# UNITED STATES PATENT AND TRADEMARK OFFICE

APPLICATION NO.	FILING DATE	FIRST NAMED INVENTOR	ATTORNEY DOCKET NO.	CONFIRMATION NO.
10/620,282	07/14/2003	James D. Pylant	067810/0303800 PI-015	7725

<b>Office Action Summary</b>	<b>Application No.</b>	<b>Applicant(s)</b>	
	10/620,282	PYLANT ET AL.	
	<b>Examiner</b>	<b>Art Unit</b>	
	Jack W. Lavinder	3677

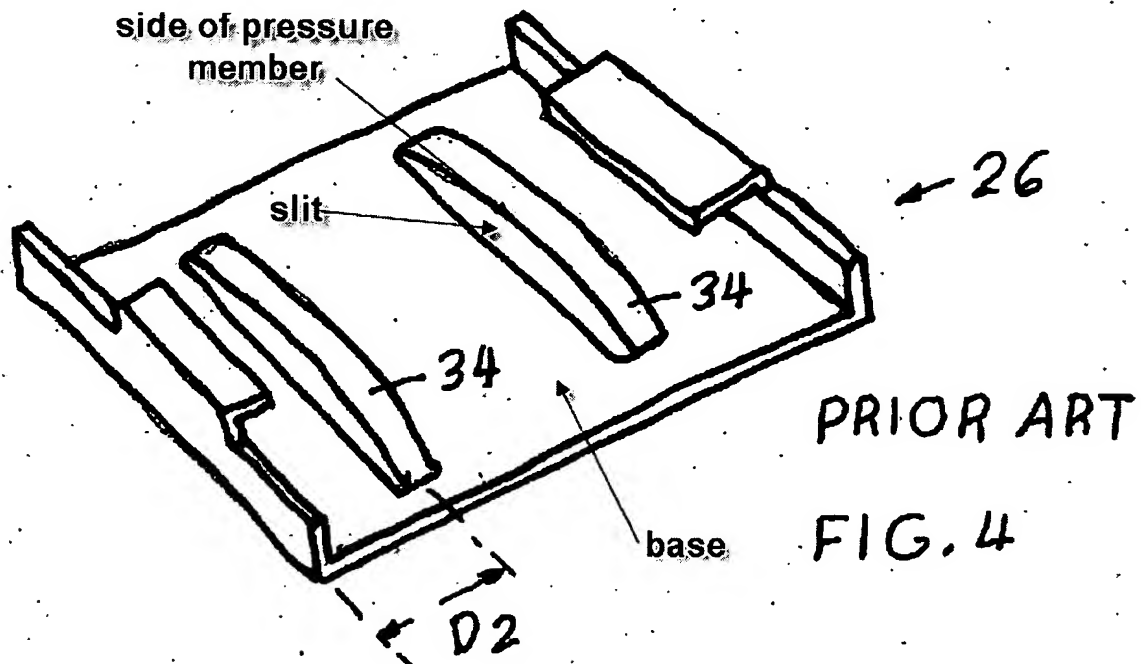
The applicant states that the prior art clip (figure 4 of applicant's specification) fails to teach a slit between the base and the side of a pressure member as recited in claims 1 and 16.

Figure 4 of applicant's specification clearly discloses a slit between the side and the base...see illustration below:

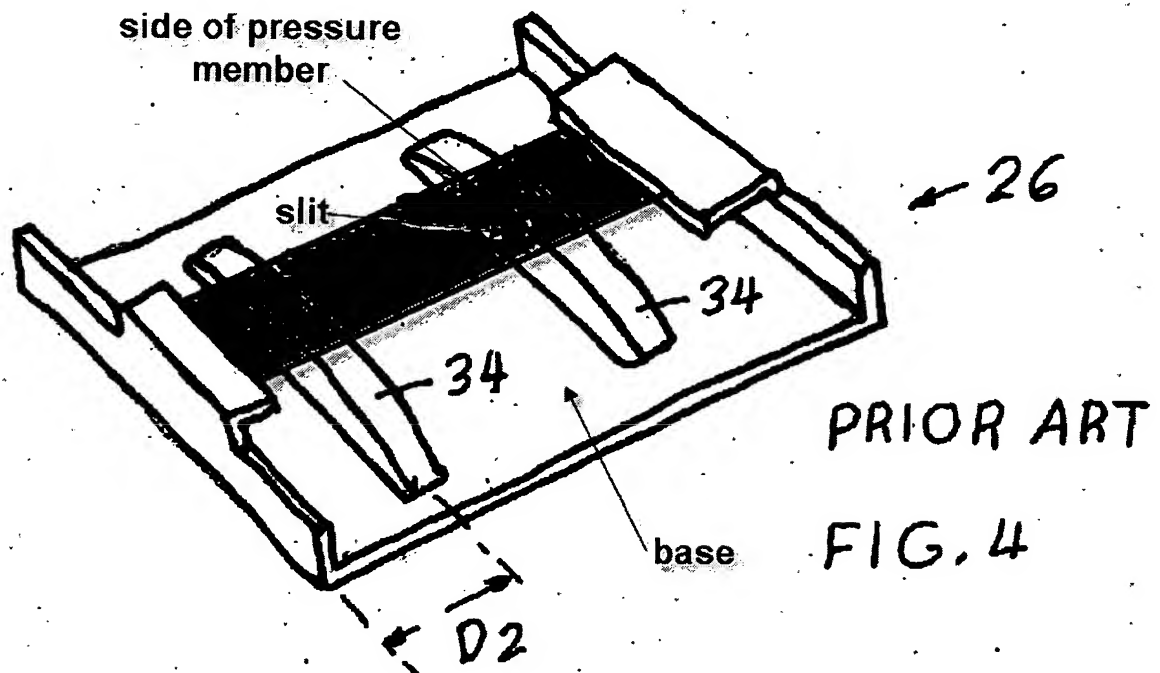
The applicant also states that the prior art device applies pressure to the center of the workpiece. This is true, but the limitations in the claim are only functional limitations. The only requirement needed to meet functional limitations in a claim is that the prior art device be capable of performing the functional limitations. In this instance, the springs (34) can apply a force "on a portion of the perimeter of the stack", i.e., if the stack is a narrow stack...see enhanced illustration of the prior art shown in figure 4 of applicant's specification.

The darkened rectangular could be a stack, wherein the pressure members (34) apply a force to a portion of the perimeter of the stack.
